**BLM SCALAR FIX** -Based on findbhudda's original design:  
<http://www.midibox.org/dokuwiki/doku.php?id=findbhudda>

#### KNOWN ISSUES / BUILD SUGGESTIONS:

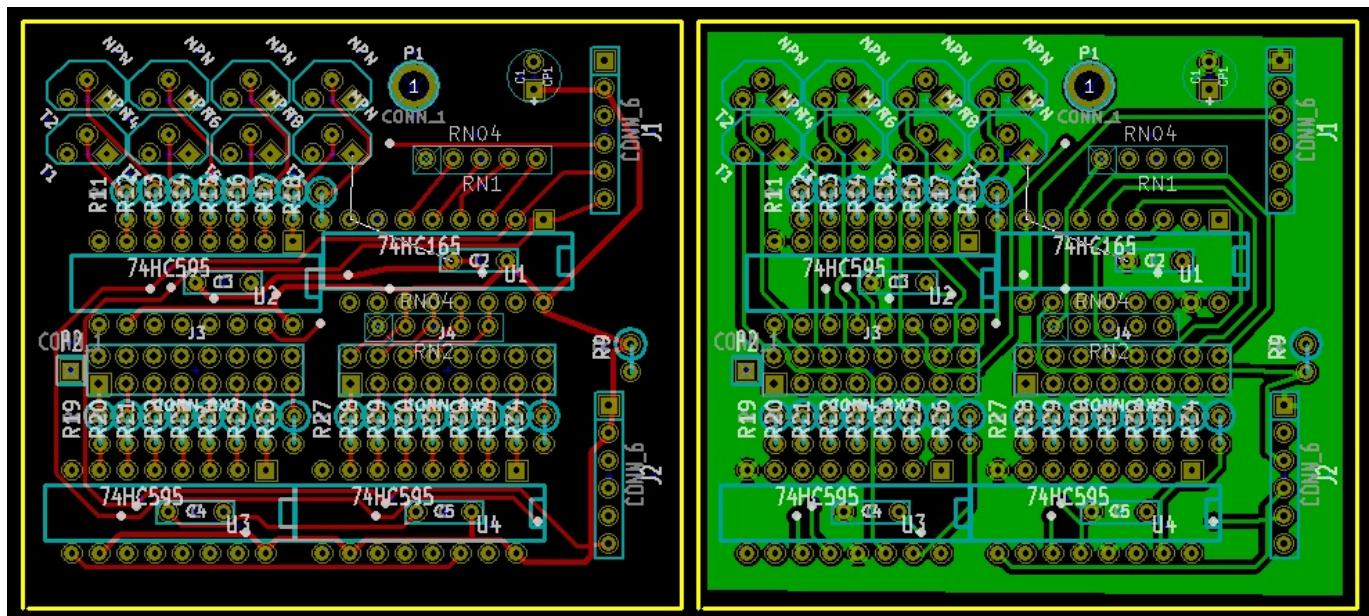
- blm-scalar.\* contain an error. Pins I4-I7 are mirrored. This is easily fixed with a connector modification, and the blm-scalar module seems to work as intended.
- blm-scalar v1.1 attempts to fix this error. Moved connectors J1, J2, Resistor Net 1 and R9 to make room for corrections.

Corrected blm-scalar v1.1.brd [blm-scalar\\_v1.1.brd.zip](#)
